REMARKS / ARGUMENTS

Objections to the Drawings

FIG. 4B

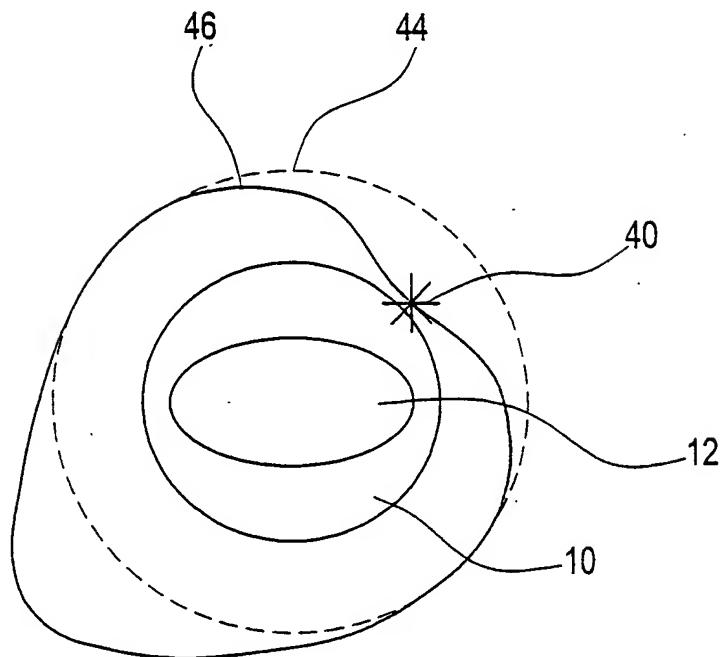
Applicant has amended independent Claim 1 to include the element of the “...wherein said operating the imaging system comprises operating the imaging system adapted to provide said angular radiation distribution comprising a first angular radiation distribution suitable for a 360 degree image reconstruction and a second angular radiation distribution suitable for a 180 degree image reconstruction; wherein said first angular radiation distribution has a first average radiation distribution, said second angular radiation distribution has a second average radiation distribution, and said first and second average radiation distributions are about constant throughout said scan.” (emphasis added), which finds support in the specification as originally filed at paragraphs [0030-0032] and Figures 4B and 5.

Here, Applicant claims a method for reducing radiation exposure that includes the operation of an imaging system, where the imaging system is adapted for 360 degree image reconstruction and 180 degree image reconstruction, and where the average radiation distribution 44 for each type of image reconstruction is about constant throughout a scan while allowing for the angular radiation distribution 46 to be modified. Paragraph [0032], lines 8-10, and Figure 5.
